In the matter of the Resource Management Act 1991
And
In the matter of the Proposed Marlborough Environment Plan

Decision of the MEP Hearing Panel

Date of Decision: 20 February 2020

Figure 1b. Recession Plane Cross Section.

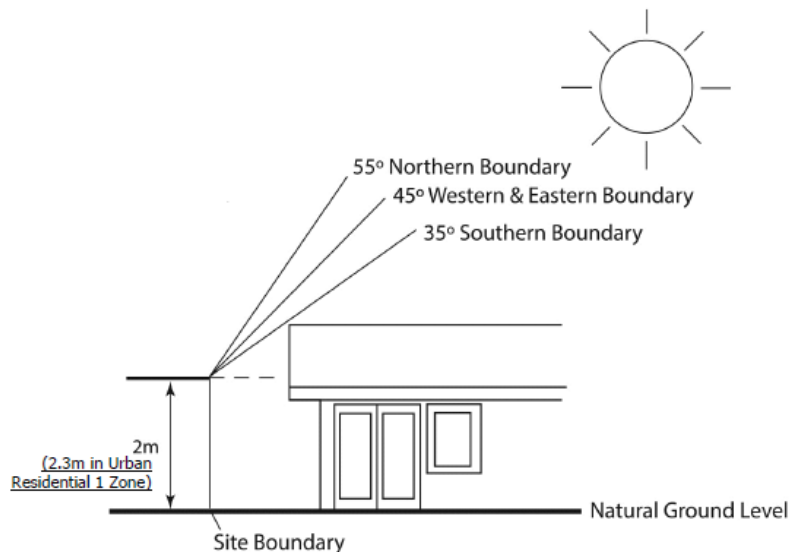
63. As a consequence, Appendix 26 Figure 1b also requires amendment to reflect the change in the Urban Residential 1 Zone, as set out in the Reply to Evidence.³⁵ A further consequential change is necessary to apply the same standard in the Urban Residential 3 Zone.

66. Figure 1b 'Recession Plan Cross Section' in Appendix 26, is amended to include the words '(2.3m Urban Residential 1 Zone)' next to '2m', as shown below:

Figure 11.3

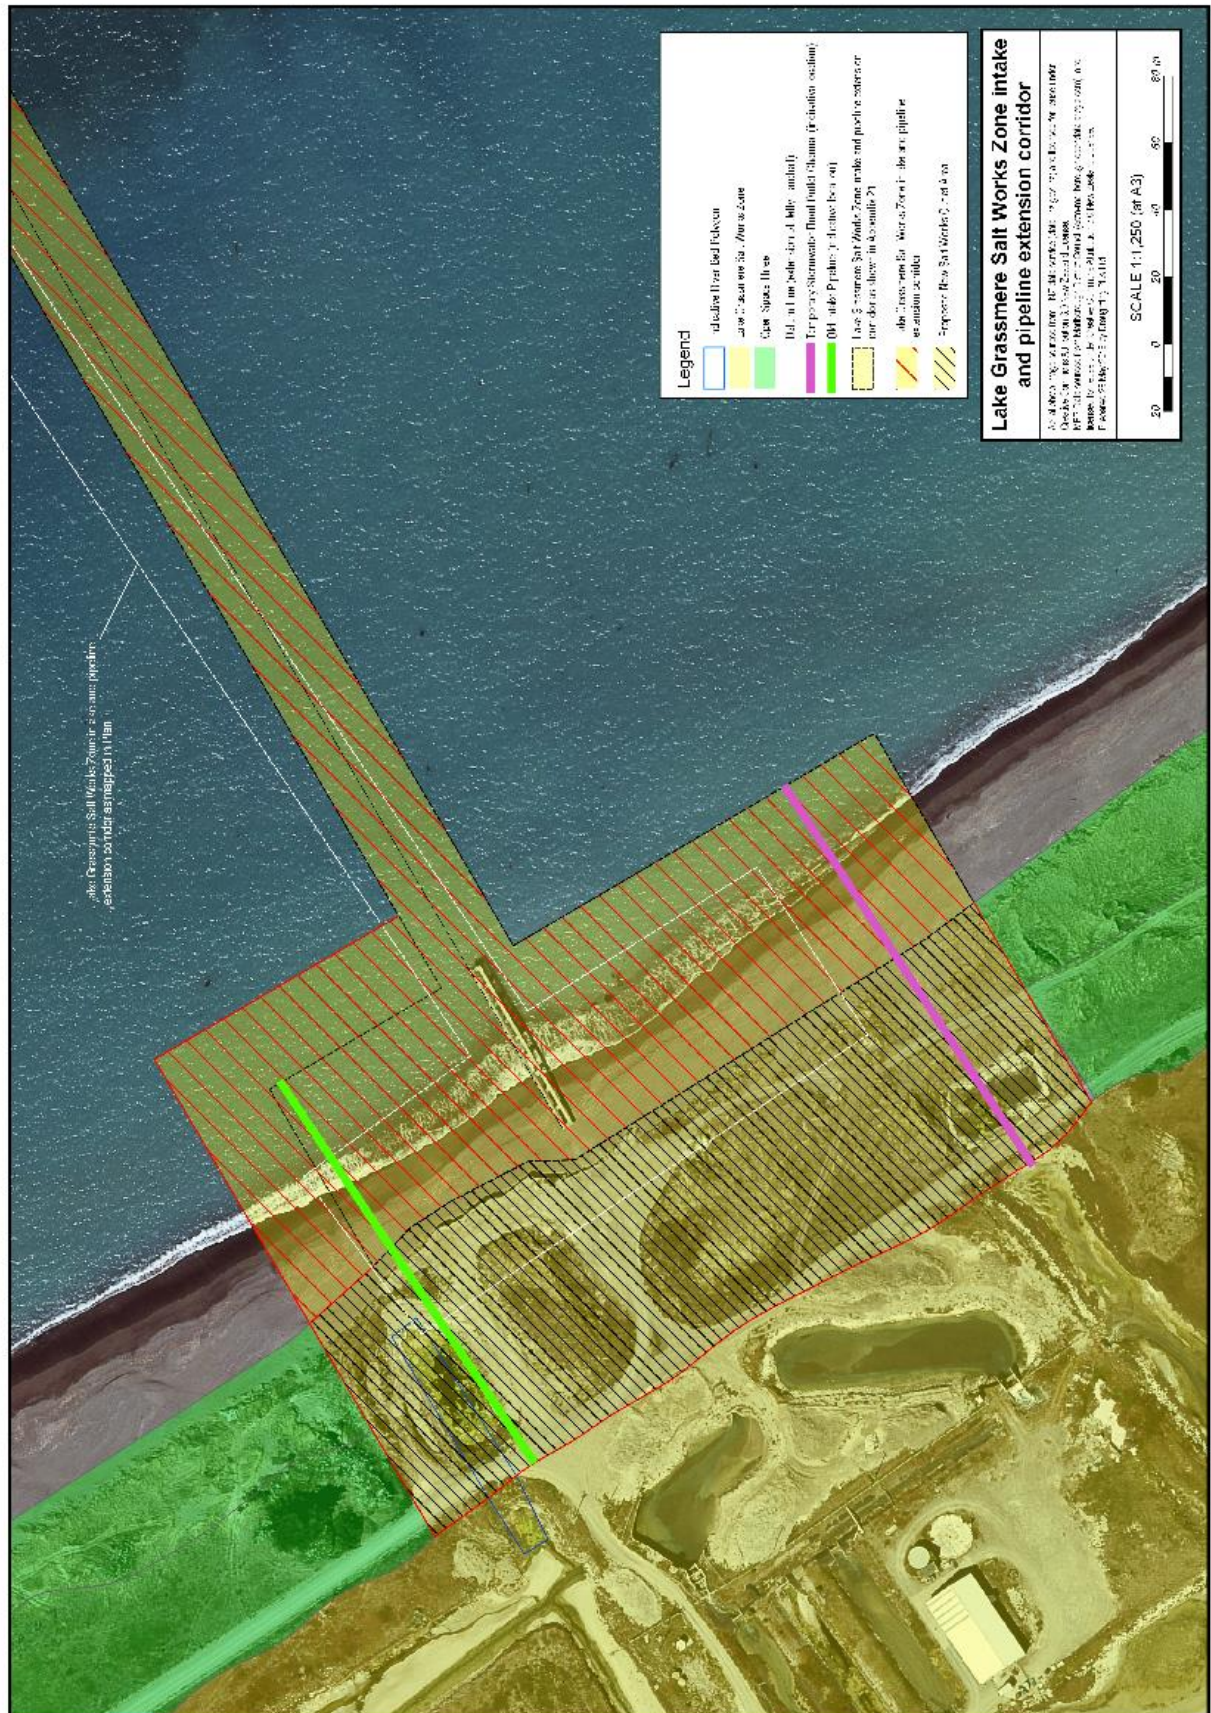
263. DSL now seek the pipeline corridor be extended 25 metres north-east, as shown in Figure 11.3, to ensure that DSL can carry out maintenance on the old intake pipeline which the company wishes to repair in the future. The old intake pipe extends seaward approximately the same distance as the current pipeline.

275. DSL’s solution to requiring a resource consent for its activities is to create a new Salt Works Outlet Area hatched in black on the map attached (Figure 11.3).⁷⁵ The rules for Open Space 3 Zone would apply as well as permitted activity Rules 22.1.2, 22.1.4 and 22.1.5. These prescribe the standards applying to the limited activities which mirror those already carried out within the proposed new Salt Works Outlet Area. In addition, DSL sought a new rule of the maintenance of the intake pipelines. These were set out in the tracked changes version of Chapter 22, provided in the response to Minute 18, dated 24 May 2018.

249. Figure 11.3 attached to this decision, taken from DSL's memorandum in response to Minute 18, now contains an accurate map reflecting the zoning amendments the company seeks. It is the result of the new assessments illustrating the changes to be made. It encompasses its operations in respect of the current and old intake pipelines. The Panel as a result of this amendment, sought further clarification from DSL if Appendix 21 to the notified plan is still accurate.
250. DSL responded that factually, Appendix 21 does not entirely encompass its operations in the intake area. The old intake pipeline is approximately only 4 metres outside the boundary of Lake Grassmere Salt Works Zone Intake and Pipeline Extension Corridor.

Figure 2.6: Vehicle Crossing for Residential Use for One ~~Rural~~ User in the Rural Environment, Coastal Environment, Rural Living or Coastal Living Zone.

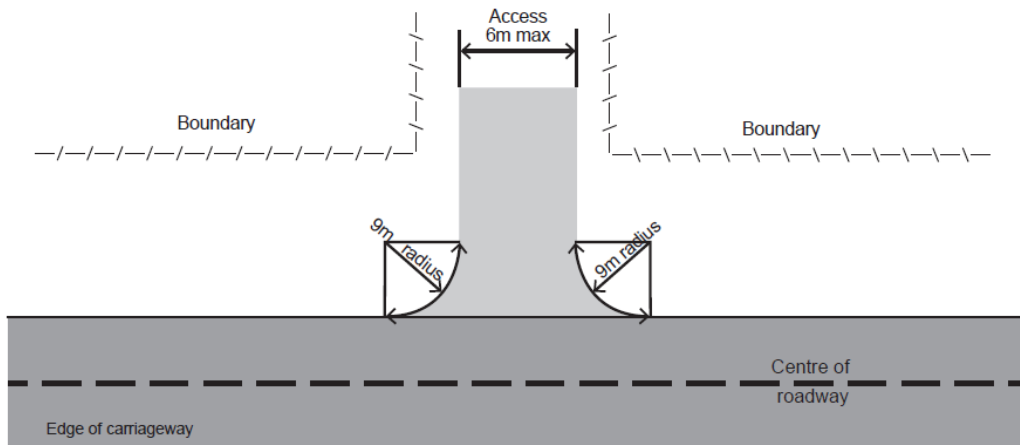
89. NZTA note that Figure 2.6 as presently drafted provides a 6.0m access. It said this should be a 9.0m radius.³⁶
90. NZTA note that Figure 2.7 should also be able to apply for some non-residential activities.

94. The removal of the word 'Rural' from the figure 2.6 and 2.7 headings is required so that there is greater certainty as to the activities that the standard applies to. The Panel was concerned that the term rural user was ambiguous.

95. While considering the above matters, the Panel found it difficult to understand the detail in Figure 2.6 and Figure 2.7, particularly the relationship between the radius and the property boundary. In following this matter up with Marlborough Roads it was suggested that an alternative would be to set out a distance along the road frontage in addition to the width of the access.

96. To assist with understanding figures 2.6 and 2.7, an alteration to the diagrammatic presentation has been made to more clearly demonstrate the setbacks required.
97. The Panel confirmed the amendment of Figure 2.6's radius measurement to state 9.0m rather than the currently stipulated 6.0m.³⁸

98. Figure 2.6 is amended as follows:

Figure 2.7: Vehicle Crossing for Residential Use for ~~23-~~ 6 ~~Rural~~ Users in the Rural Environment, Coastal Environment, Rural Living or Coastal Living Zone

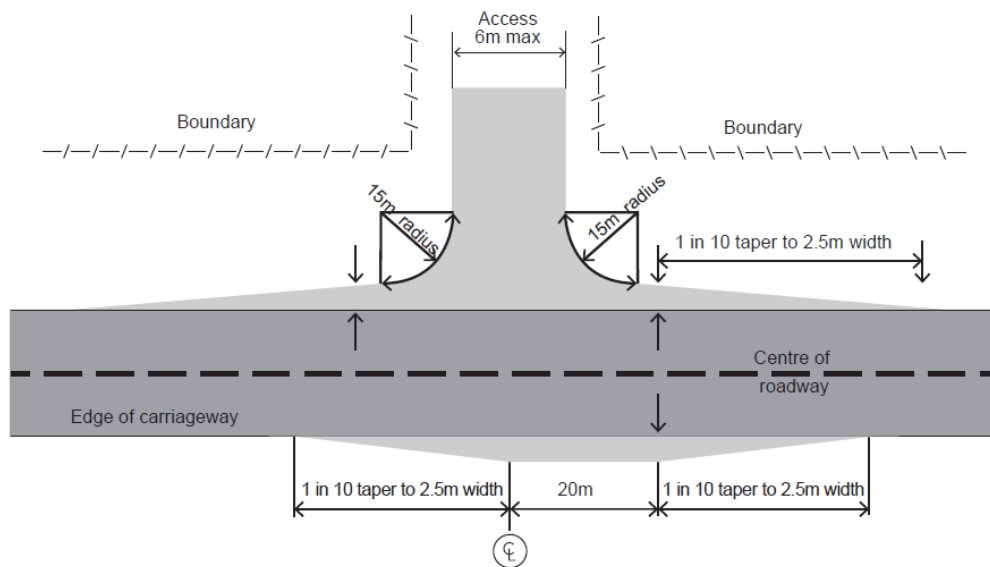
93. Figures 2.6 and 2.7 should apply to some non-residential activities by adding 'appropriate non-residential use' to the figures and renaming the term 'Rural' in the Figure headings so that they apply to any residential use only. There is also no clear direction or diagram for activities that are not residential. NZTA seek to add 'and agreed by the Road Controlling Authority' to the end of 2.32.4.3 acknowledging that activities other than residential must be constructed to a commercial standard. This is not accepted by the Panel because it provides discretion to a third party.

99. Figure 2.7 is amended as follows:

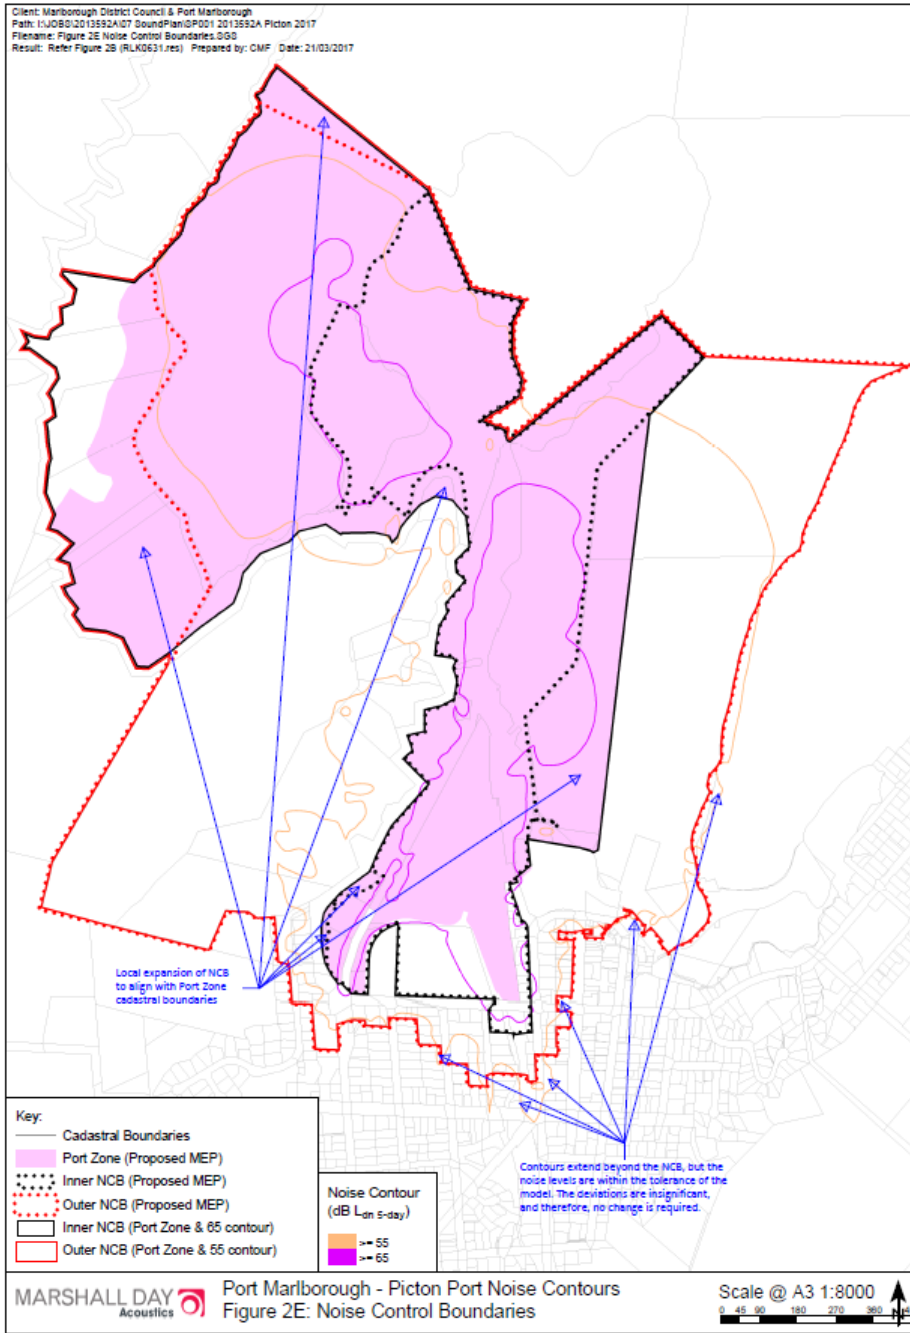
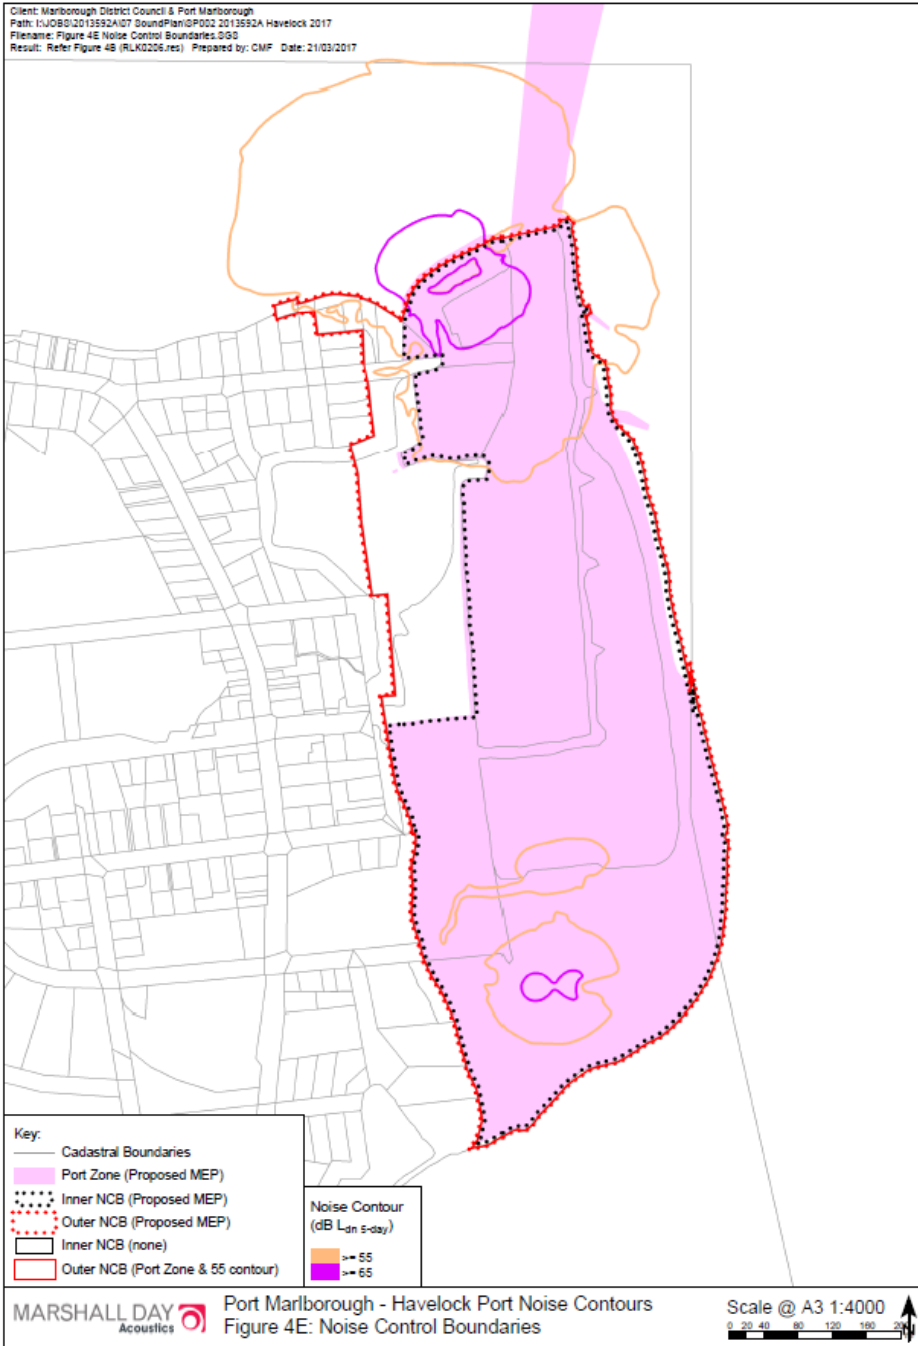
- *We recommend that NCBs be expanded to align with the outer extents of the Port Zone boundaries where the noise contours do not extend beyond. This as a practical simplification with no material change to the noise effects or applicable controls. With reference to Figure 2E, there are six locations in Picton and Shakespeare Bay where proposed NCB's are positioned within the proposed MEP Port Zone.*
- *The revised future contours extend beyond the proposed MEP Outer NCB in six locations in Picton. However, no changes to the NCBs are recommended in Picton because changes in predicted noise levels are within the tolerance of the model and not significant.*
- *The Havelock rules relate to the Outer NCB. Therefore, we understand that the Inner NCB serves no purpose and has been removed for simplicity (note if retained it would be unchanged).*

186. The Panel adopted the revised boundaries based on Marshall Day remodelling. This reflects both accurate and up-to-date information but also a degree of practicality where the noise control boundaries do not extend to the Port Zone boundary. As the purpose of the noise control boundary, and associated rules, is to manage adverse noise effects beyond the port, the Panel agrees that in this situation the noise control boundary should be located at the zone boundary.

187. The Picton port noise control boundaries are amended to reflect those shown on Figure 2E: Noise Control Boundaries, attached to the evidence of Port Marlborough and shown below.
188. The Havelock port noise control boundaries are amended to reflect those shown on Figure 4E: Noise Control Boundaries, attached to the evidence of Port Marlborough and shown below.

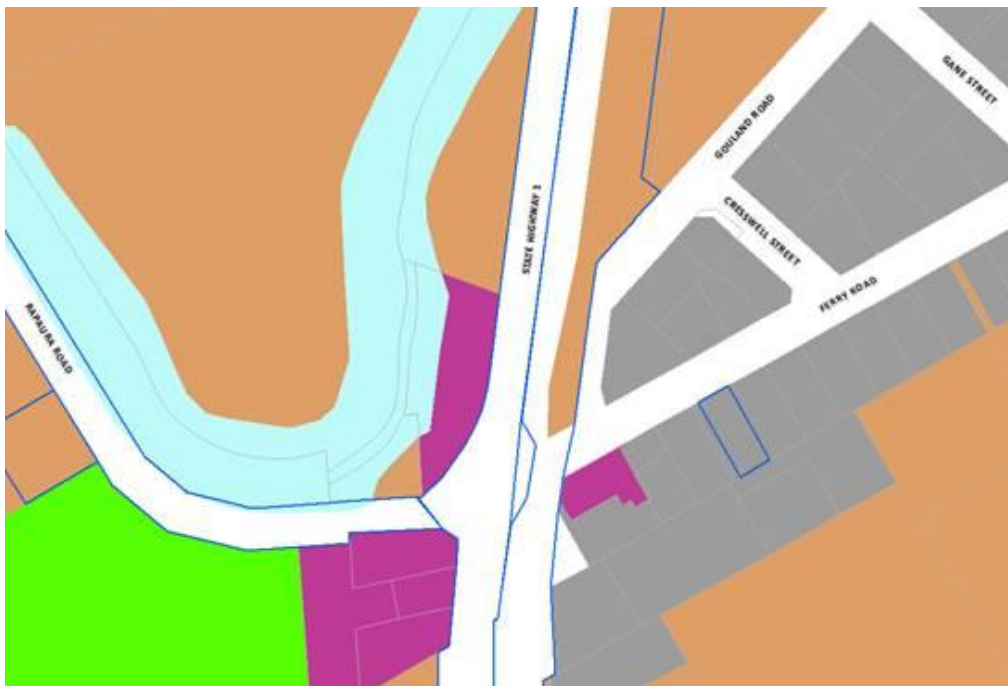
88. Kiwirail sought two changes to the designation. One of which was supported by the S42A report writer and one that was not. The Panel was not convinced that the land zoned Open Space 3 was required for rail operations. In contrast the adjoining area, which the Panel did

- 89. Maps 218 and 234 are amended as below:
